**Commercial Preliminary Development Plan
Applicant's Letter**

Application Number: PL2015117
Application Type: Commercial Preliminary Development Plan
Application Name: SUMMIT CHURCH
Location: 3381 NW CHIPMAN RD, LEES SUMMIT, MO 64081

Analysis of Commercial Preliminary Development Plan:

STORM SEWER PLAN & PROFILE
The Summit Church:
Lee's Summit, Jackson County, Missouri

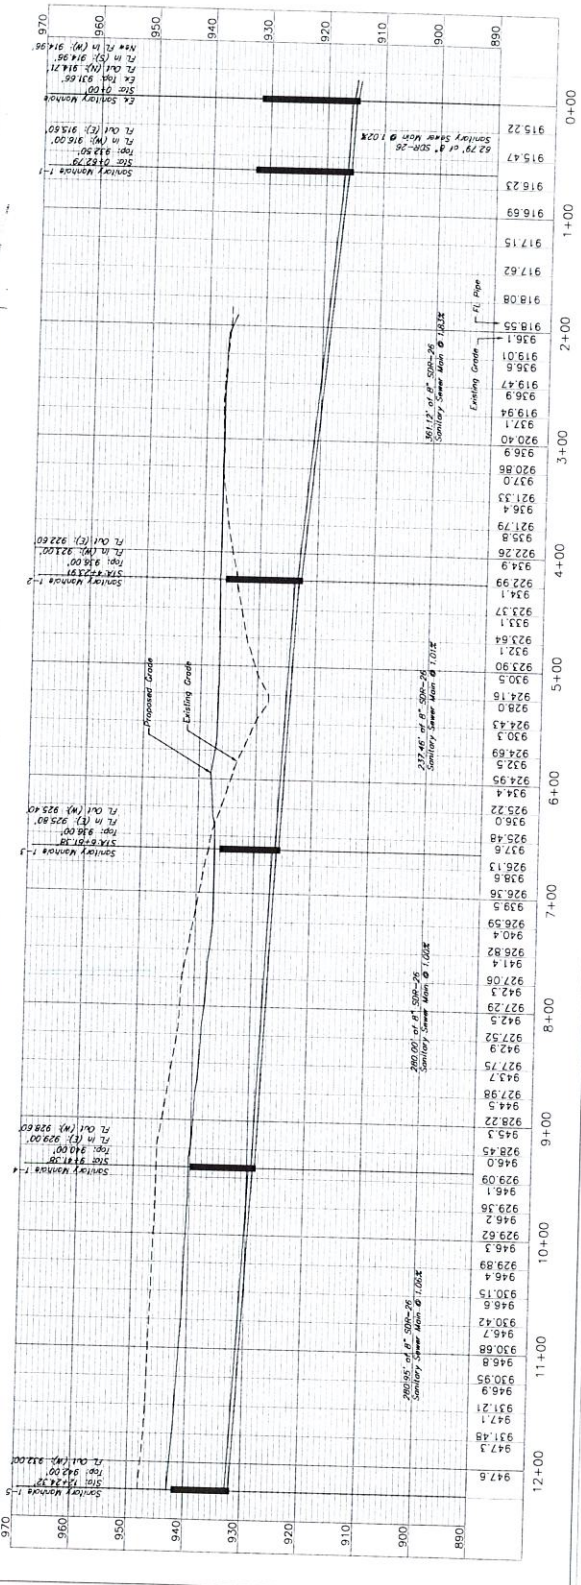
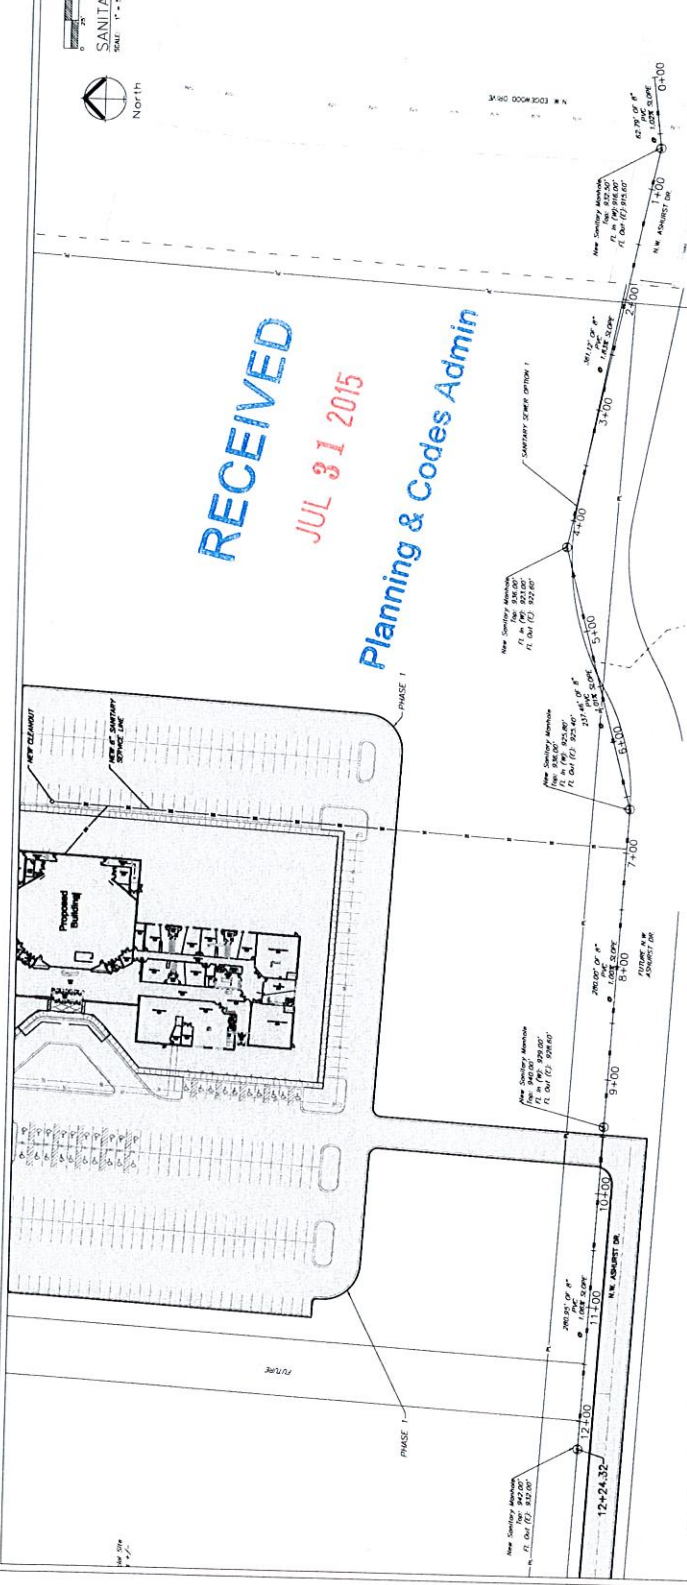
15. Sheet C.201: The profile view shows a public street. As discussed previously, these access roads will be considered private until such time that the area is platted. The roads will need to be built to public roadway standards, however.

LANDSCAPE WORKSHEET

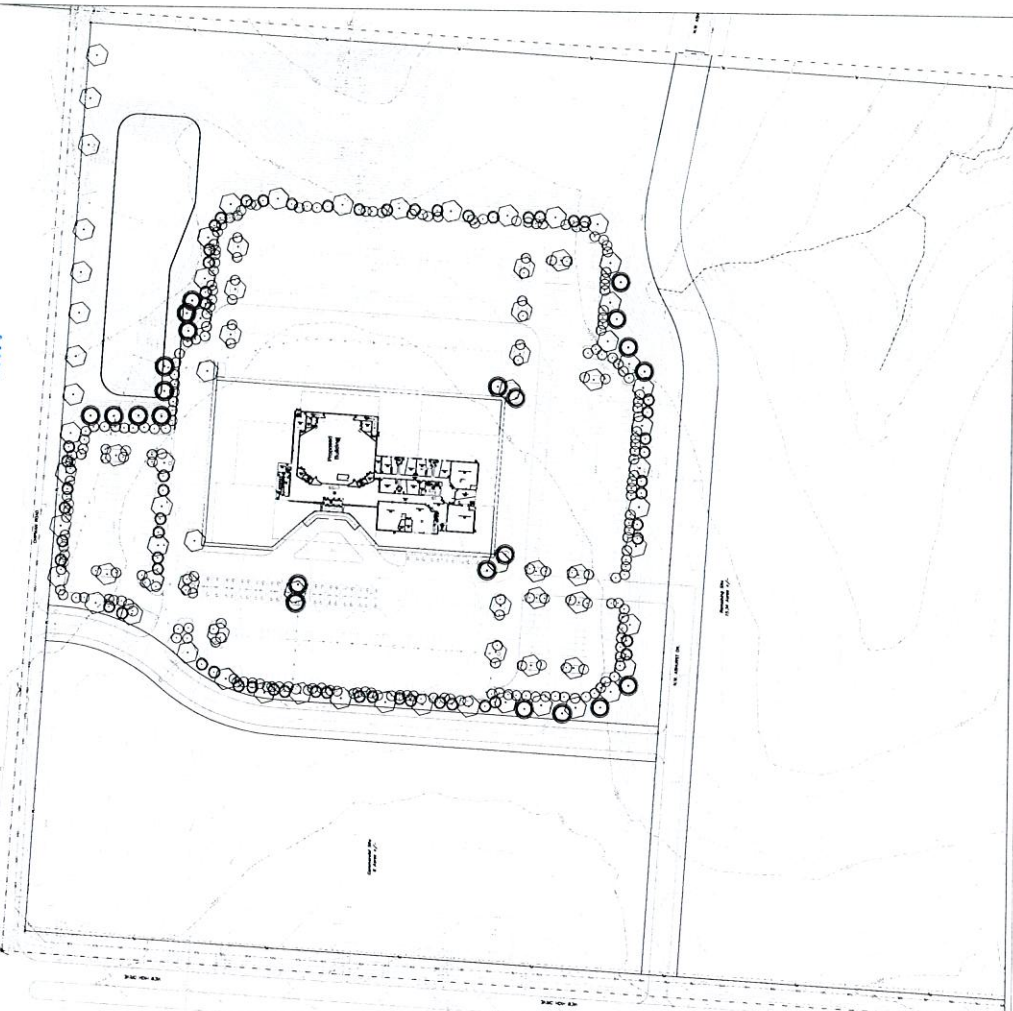
- Deciduous trees shall be a minimum 3" caliper. The proposed Linden and Redbud trees do not meet the minimum size.
- Evergreen trees shall be a minimum 8' at the time of planting. The Skyrocket Juniper tree does not meet the

minimum size.

- Revise the landscaping calculations so as to only reflect the lot area for the boundaries of the property that will make up the church's lot itself. Do not include the future 6-acre commercial site.
